BWX Technologies, Inc.

May 3, 2018  
18-026

Subject: Responses to Additional Information Request on Revised Request to Amend License SNM-42, Chapter 5, *Nuclear Criticality Safety*

**Summary of NRC Requests for Additional Information (RAI) with BWXT  
NOG-L Responses for Amendment Request for Chapter 5 of the SNM-42  
License Application**

**Figure 1: Sketch of Models to Assess Top Reflection**

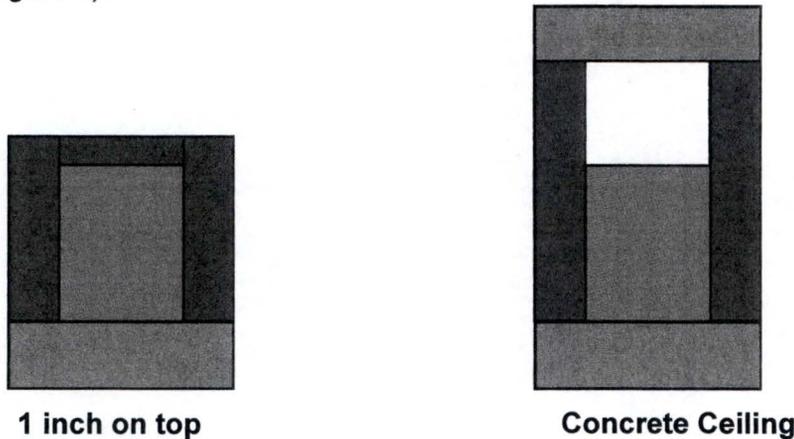
- (3) The fourth paragraph of LA Section 5.2.2.4 contains the following: “If there is a concrete roof over the fuel, the more reactive of a 1 inch thick water slab or the concrete at its actual height and using its actual thickness shall be used. (In the case of the concrete ceiling, the water box will extend to the ceiling.) These two sentences appear to contradict each other in regard to the thickness of the water box to be modeled. Clarify what boundary conditions will be applied when there is a concrete roof over the units being modeled.

- (3) Extending the water box means the lateral sides. To assess the concrete ceiling, the water box would be modeled with the 12 inches on the side and 1 inch directly on top. The model would then have the 1 inch water on top removed; the sides of the water box would be extended up to the concrete ceiling and the ceiling model with its actual thickness (see Figure 1).
